Project name:
 St Mary's Hospital : Interim Access Road

Technical Note

Subject: St Mary's Hospital, Interim Access Road

AECOM has been commissioned by Imperial College Healthcare NHS Trust to provide transport advice for the comprehensive redevelopment of the St Mary's Hospital site, located in Paddington, West London. This Technical Note (TN) provides a response to the Transport for London (TfL) letter to Dr Tracey Batten dated 4th May 2017 and the WSP | Parsons Brinckerhoff (WSP|PB) drawing reference 8427-SK-132 Rev B.

TITLE: COMPARISON BETWEEN PLANNING APPLICATION AND PROPOSAL FOLLOWING RSA DESIGNERS RESPONSE

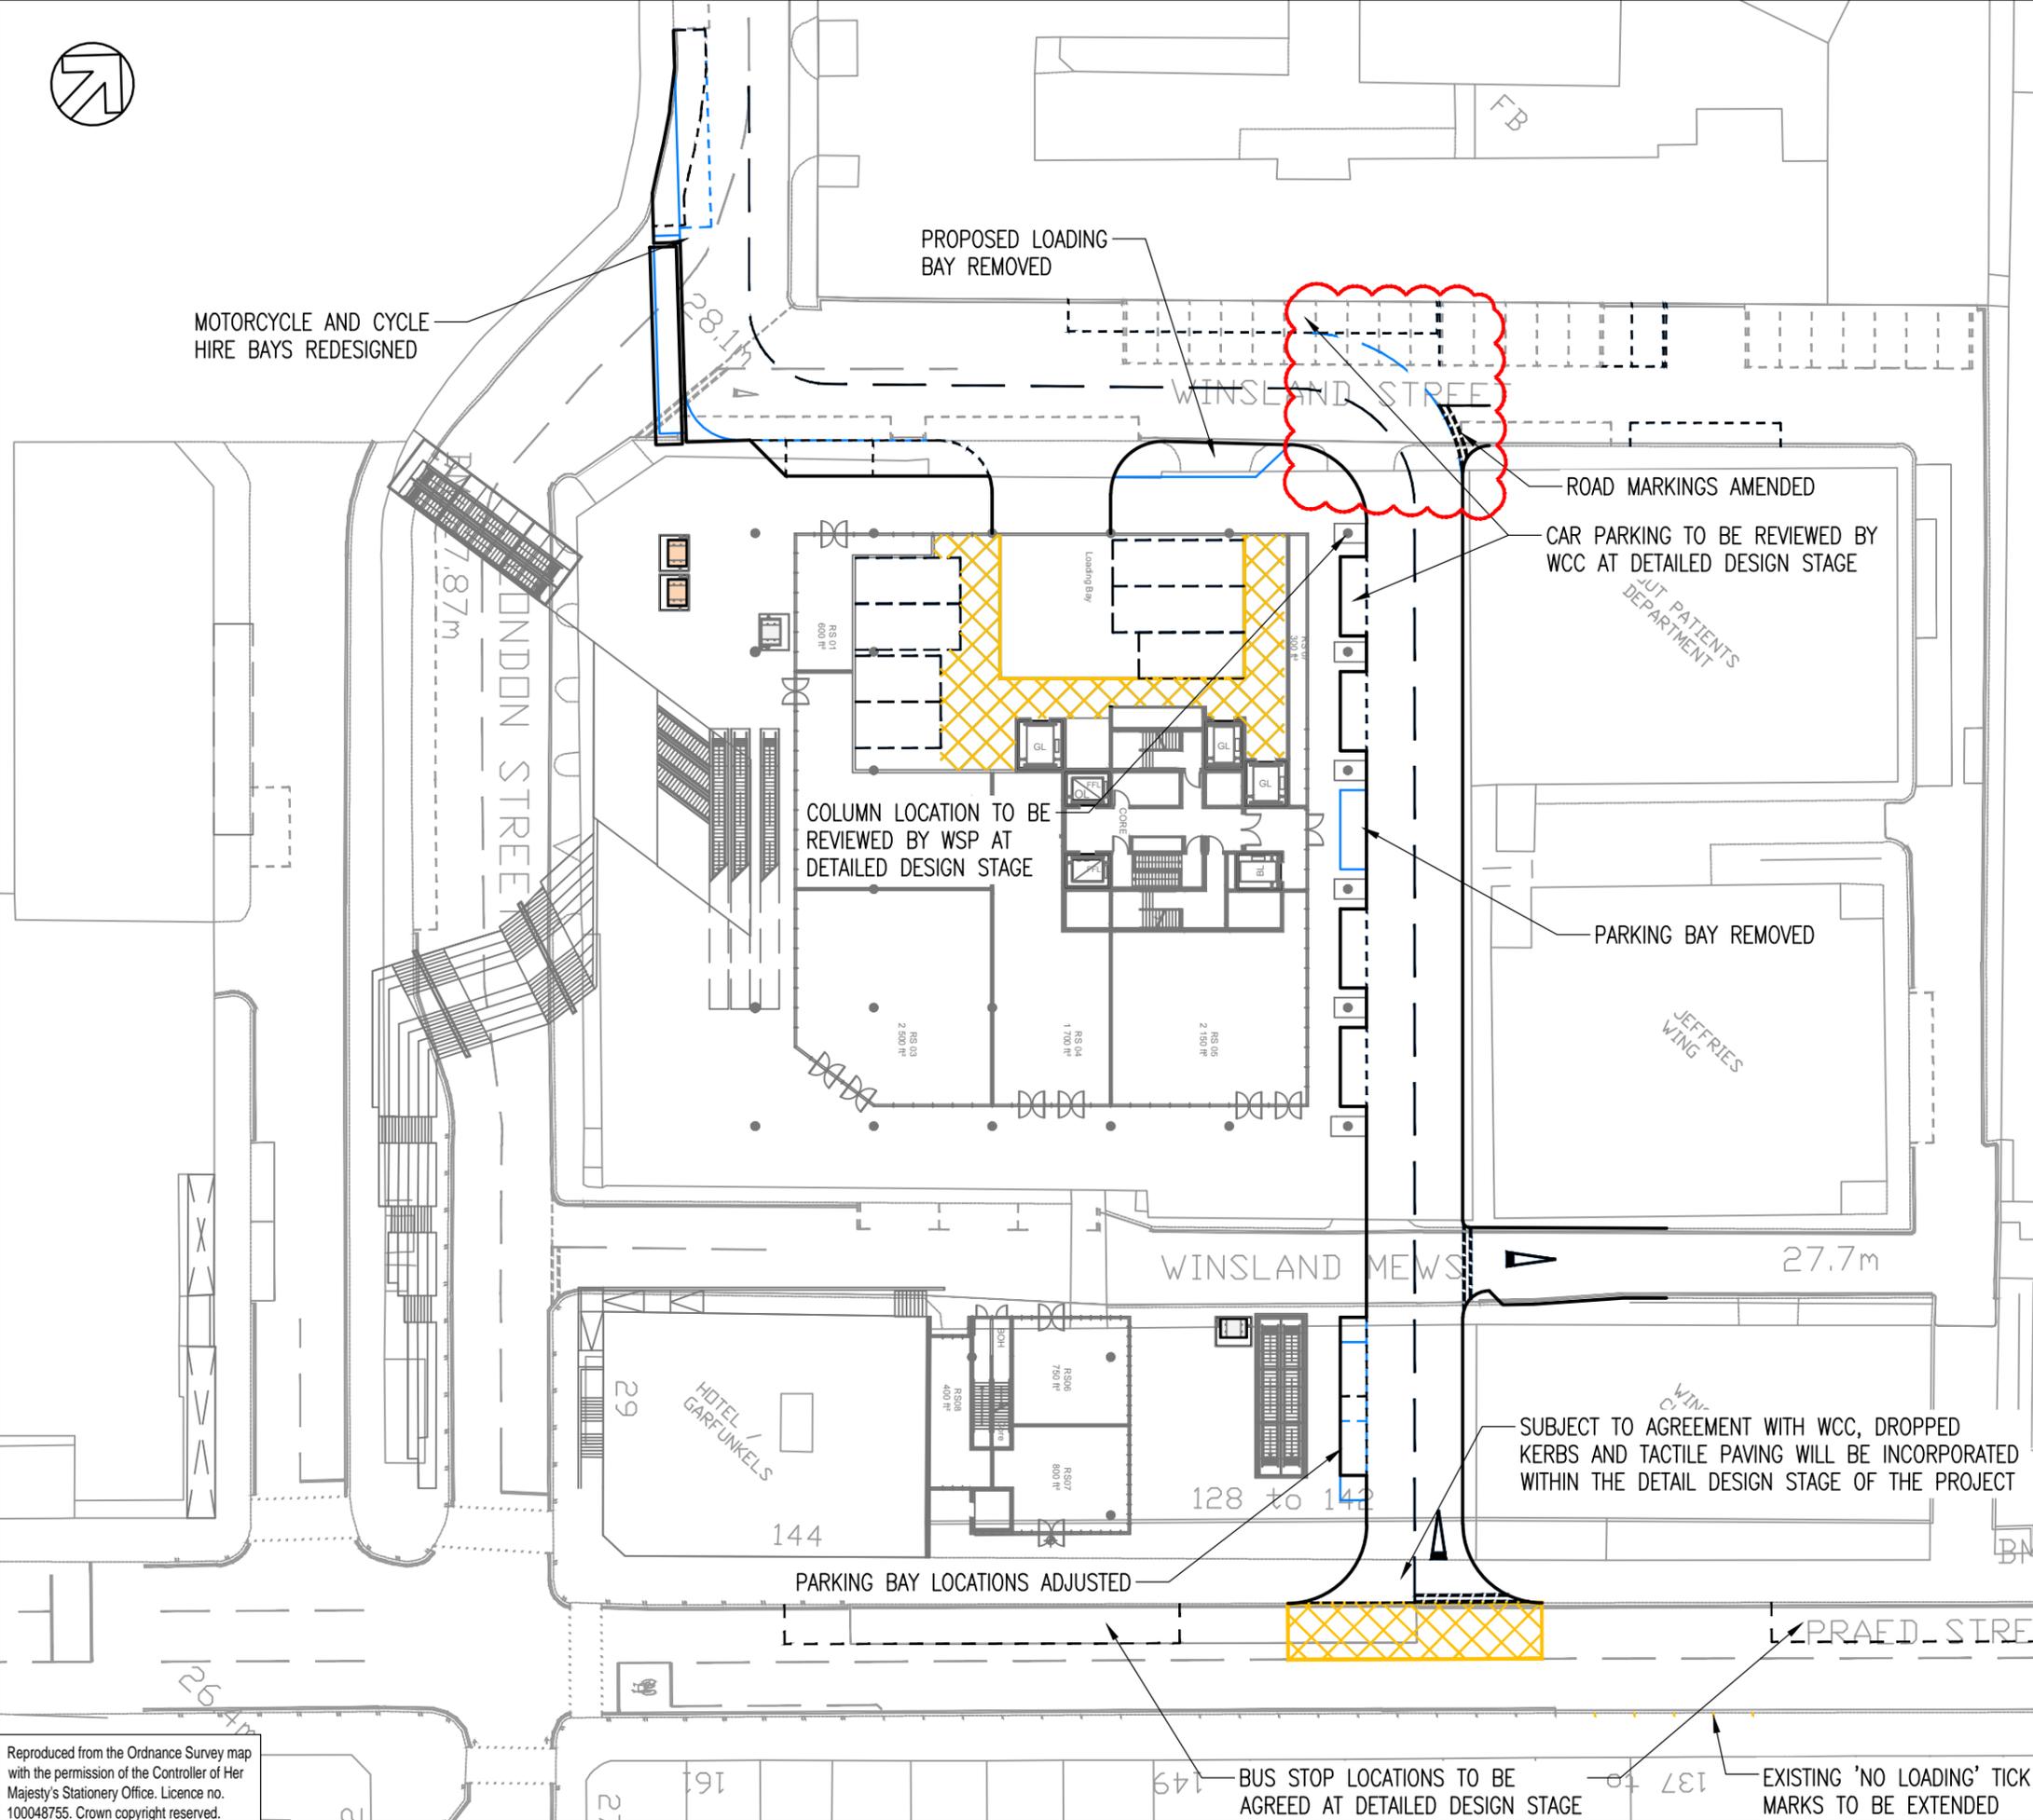
A – TfL state that the level of visibility available from the proposed service yard at 2.4m x 17.7m (following the removal of the loading bay to the east of the access) meets the recommended minimum visibility guidelines as set out in the Department for Transport's Manual for Streets 2. Therefore there would be no requirement to relocate the service yard further west. This level of visibility has been determined based upon the existing speed of traffic on Winsland Street. It is difficult to see how visibility splays from the service yard could be determined based upon the existing speed of traffic on Winsland Street as this road will be fundamentally changed by the development proposals. Instead visibility splays should be based upon the design speed of the road proposed. The route will have a 30mph speed limit and therefore this would be an appropriate starting point for the design speed of the road. As such the visibility requirement in accordance with Manual for Streets 2 as cited by TfL as being the appropriate guidance would be 43m. However, acknowledging that the speed of traffic on the interim access road and past the service yard itself will be constrained by the two dog legs introduced. If the interim access road is to be a replacement for London Street, it is not unreasonable to expect this route to be designed to accommodate traffic at the same speed as the existing. Traffic surveys undertaken for the Trust in 2015 showed a seven day average all vehicle speed northbound of 19.14mph (85th percentile). Taking this speed would require a visibility splay of 23.5m. In addition, the seven day average top speed of all traffic recorded

on London Street in the survey northbound was 27.9mph. Considering this is a blue light route it is not unreasonable to assume that this is the speed at which emergency ambulances are travelling. This would require a visibility splay of 38.7m. The level of visibility from the proposed service yard is therefore inadequate and our recommendation to relocate it further west, appears the most suitable mitigation for this particular issue.

B – TfL state that they are content the service yard has been suitably sized to accommodate the volume of traffic anticipated and that movements will be controlled through a Service Management Plan. However, following the removal of the on-street loading bay it should be conditioned that all servicing takes place off-street to prevent congestion on Winsland Street occurring.

C – AECOM raised concern with the presence of parking at the northern end of the interim access road at the junction with Winsland Street. In response TfL have requested that AECOM provide tracking plots to demonstrate the extent of this issue. This would be for the applicant to undertake not AECOM. However, more importantly this appears to ignore the concern raised, which for clarity is that vehicles manoeuvring into and out of these spaces would prevent a vehicle from being able to enter the eastern section of Winsland Street from the interim access road. This would then in turn block the interim access road and cause congestion. The congestion has the potential to delay emergency service vehicles on route to the hospital which is unacceptable. The recommendation that the parking layout will be reviewed at detailed design is not sufficient. This is a significant issue with the design presented and requires a suitable solution prior to consent being granted. If, at detailed design it is found that the parking cannot be accommodated in this location, there is the potential that parking would have to be omitted which would have a detrimental impact on the day to day operation of the hospital. This situation would be unacceptable and therefore requires resolution now.

D - AECOM raised concern with the presence of the northern most parking bay on the western side of the interim access road and the column which both will limit forward visibility around the bend for northbound traffic. As stated in response to item A the design speed assumed by WSP|PB is insufficient given the purpose of this route and the type of vehicles it will carry. Forward visibility is therefore inadequate and the design unacceptable. It is welcomed that WSP|PB have agreed to review the provision of this parking space and the column location but the fundamental concern remains. These items should be removed from the design. If this is not possible, the interim access road in its current form is sub-optimal to the existing situation and should not be progressed.

E – AECOM recommended that parking is considered on the Paddington Cube site to mitigate the potential loss on-street and the detriment this will have to the operation of the hospital. TfL dismiss this as being contrary to policy and on the grounds that only four parking spaces are being lost. However, the total volume of parking that will be lost as a result of the development is not known at this stage. If, as AECOM have previously highlighted, the loss of parking could be much greater once the review at detailed design has taken place, this need for alternative parking could become greater. The provision of parking on the Paddington Cube site would not be contrary to Westminster Council policy and should therefore be explored.

In addition, the parking proposed on the western side of the interim access road close to the Praed Street junction should be removed.

F – AECOM have highlighted the inadequate visibility from the Winsland Mews junction with the interim access road and the road safety issue this presents. TfL have dismissed this on the basis that the volume of traffic using this link is low. It is poor practice for a new highway to be designed with a clear road safety constraint, especially given the significance of this link. This issue could easily be rectified by realigning the road further west as recommended by AECOM. If this is not possible, the interim access road in its current form is sub-optimal to the existing situation and should not be progressed.

G – The implementation of the interim access road will require the relocation of the bus stop on Praed Street. TfL have agreed the location can be confirmed at detailed design. AECOM are content that this can only be addressed at detailed design but would seek to ensure that sufficient visibility from the access is guaranteed.

H – Double-yellow lines should be extended to the east on the southern side of Praed Street along with the no loading restriction to ensure that access to the interim access road remains clear at all times. The plan prepared by WSP|PB indicates an extension to the no loading restriction but not the double-yellow lines. Both need to be extended to the east.

I – The provision of an uncontrolled crossing at the northern end of the interim access road should be provided along with a footway on the northern side of Winsland Street east of the interim access road. It is welcomed that the uncontrolled crossing will be incorporated into the detailed design. The footway widening could be provided by the developer under a section 278 agreement by narrowing Winsland Street. This should be secured by condition.

J – Servicing of the linen store by smaller vehicles to enable them to enter and exit in a forward gear. The need for this measure is created by the Paddington Cube development and as such any cost implication of this should be funded by the developer and secured through the S106 agreement.

K – The offset between the carriageway of the Interim Access Road and Outpatients Building is as small as 0.587m. Once boundary lines are taken into account it is considered that the lateral clearance that remains within the highway will be less than 450mm. As such this design is insufficient and the carriageway of the interim access road should be relocated further west.

The drawing prepared by WSP|PB to identify the areas of change from the planning application requires some further amendment to reflect the recommendations that have been made.
